# Rye Neighbourhood Plan 2016 - 2028

## Rye Response to the Initial Comments of the Independent Examiner

**Map 1: Proposed Development (Minor) Boundary Change to include Rye Primary School**

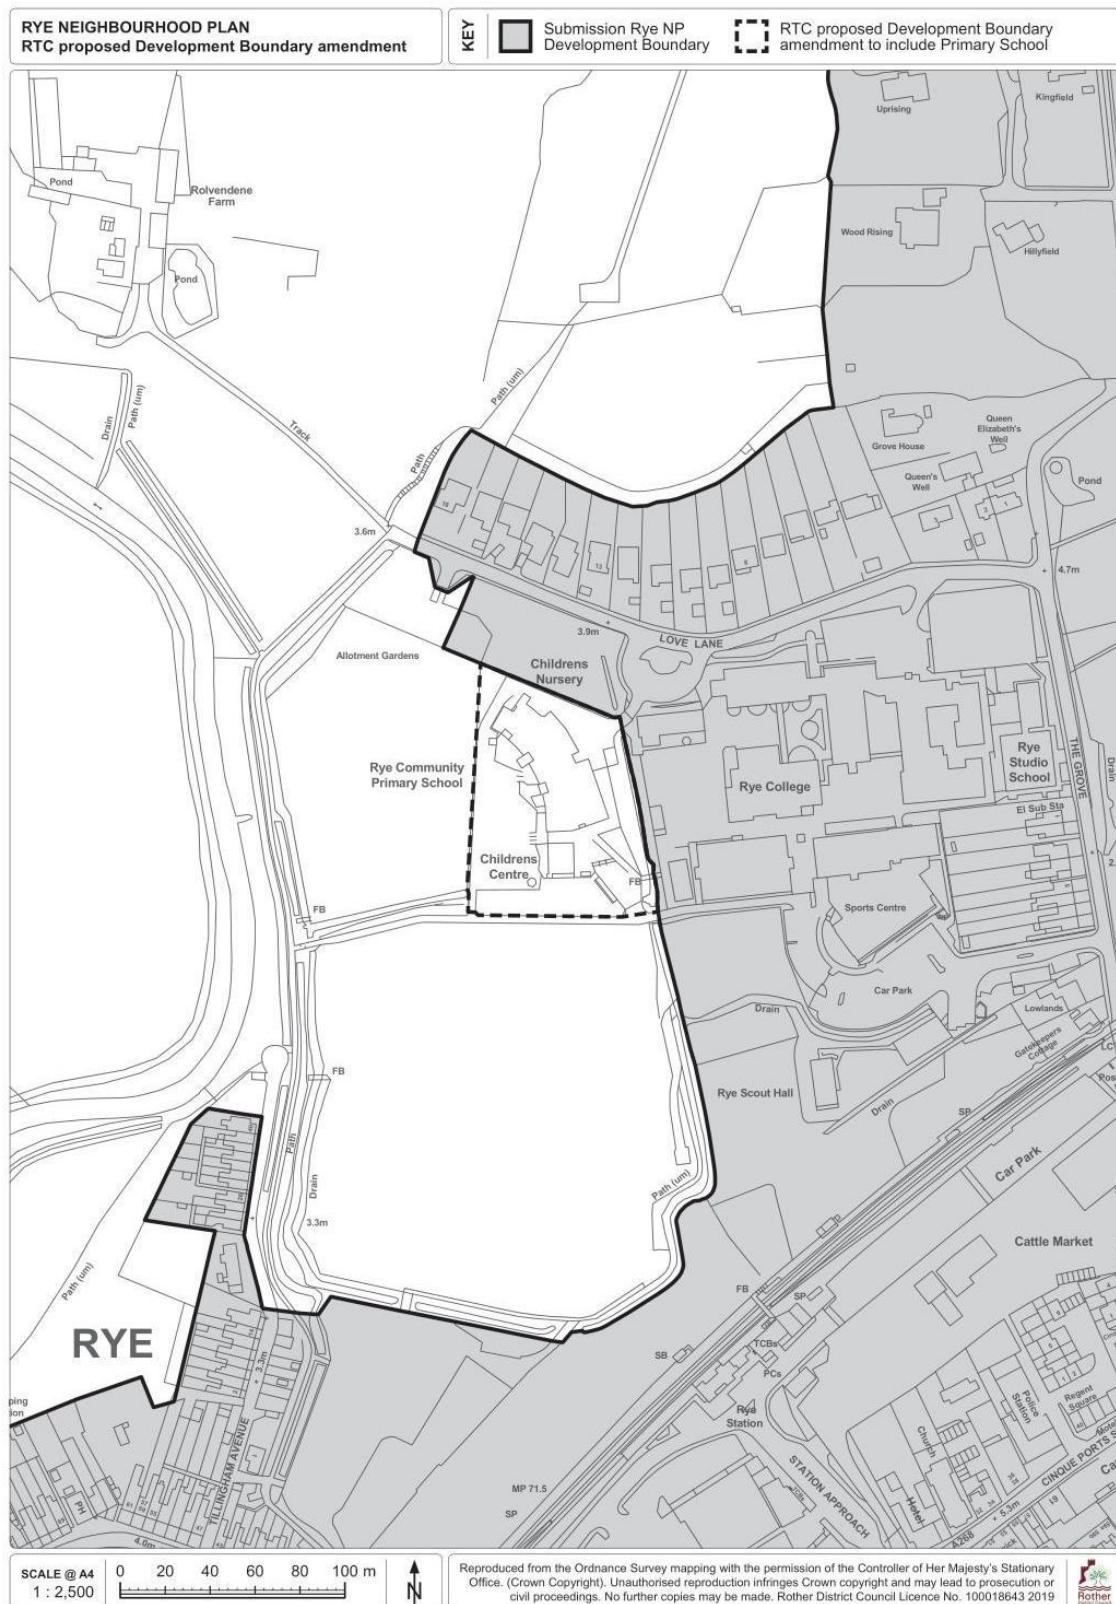
**P15 (Rye)** Minor amendment to the development boundary RNP Figure 2 (Map 1 below) to include the new Primary School.

**Map 3 – Environment Agency Land in Red (For illustration only - 2005)**

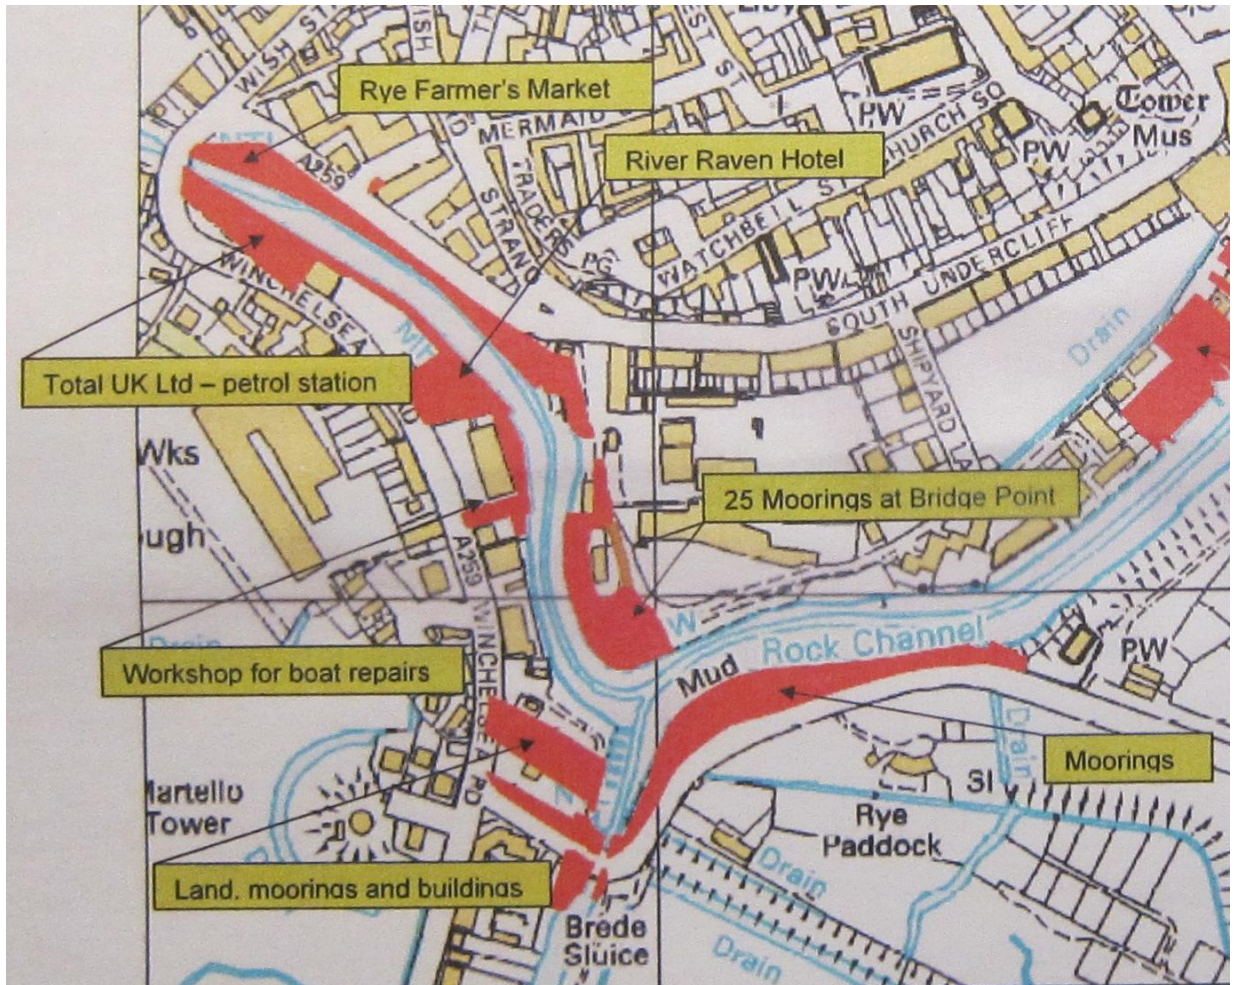
6. I was surprised to see that for a linear waterfront site of this size, the Rye neighbourhood plan is proposing only 10 dwellings. It seems there is scope for a higher density scheme on this waterfront. Is there a particular reason why the site is only expected to deliver 10 units, how was that figure arrived at, and is the site likely to be viable with this level of development? I understand that the site is in different ownerships. Is there an expectation that the District Council will use CPO powers to ensure the site is developed on a comprehensive basis? Who is expected to be the body that will prepare the masterplan? Rather than requiring the development to be comprehensively undertaken, would it not be a more deliverable option to require the development to be carried out in a manner that does not prejudice the development of the remainder of the allocation site? Is the District Council able to provide me with information as to ownerships and whether there is a possibility of a design guidance/ development brief being prepared, that could be used to provide the guidance sought by the Town Council?

There has been significant consideration of this broad location during the neighbourhood planning period, as reflected in site assessment document. The map on P52 of the Site Assessment (RNP Support 2) indicates the varied land ownership (Map 4), with differing aspirations for development, which includes four parcels by the Environment Agency (EA) (RED on Map 3).

Rye seeks a comprehensive development as a desirable outcome, but having discussed again with Rother DC Planning Officers, it is agreed that in Policy H5:

~~DELETE: “Development of the location will need to be undertaken on a comprehensive basis and according to an overall master plan”~~

*INSERT: “Development should be carried out in a manner that does not prejudice the remainder of the allocation”*
